Stormwater Management Plan
Approved as shown and/or noted *
JAMES R. GILLS, P.E.
County Drainage Engineer
By J.S. Date 9/5/13

SITE PLAN FOR
B.V.Q HOMES

BEING S1L10 IN THE CROSSROADS AT SUMMERWOOD AS RECORDED IN VOL 53-22-2 L.C.R.P.S.
TOWNSHIP OF CONCORD COUNTY OF LAKE STATE OF O

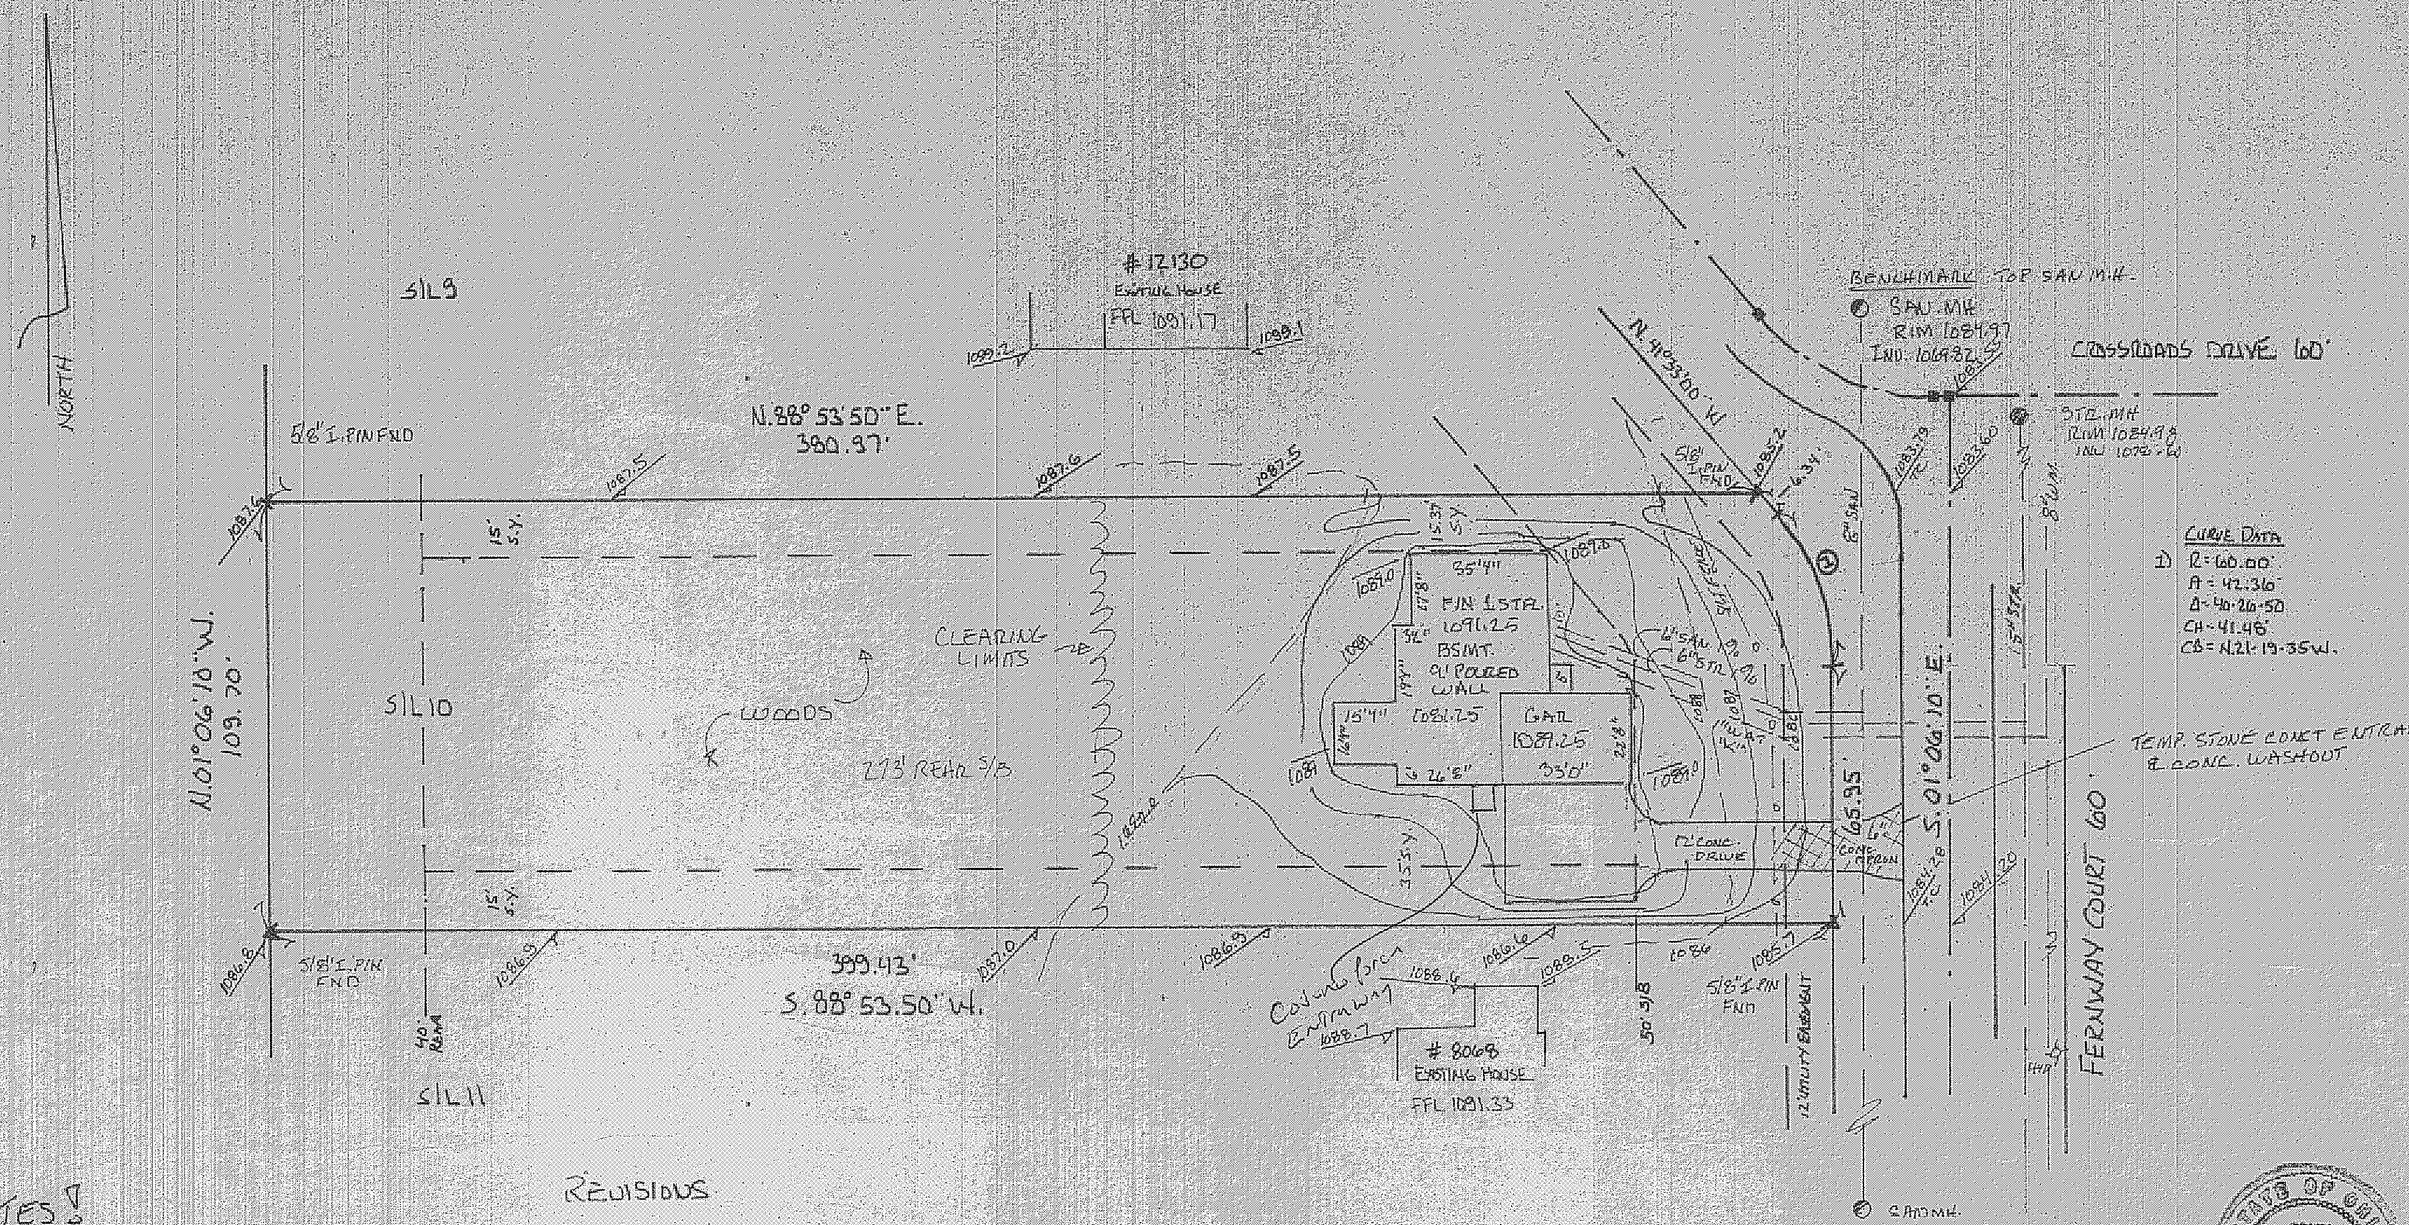
THIS SITE DOES NOT MEET THE REQUIREMENT FOR THE FOOTER DRAINS TO BE CONNECTED TO THE STORM SEWER WITH OUT A SUMP PUMP
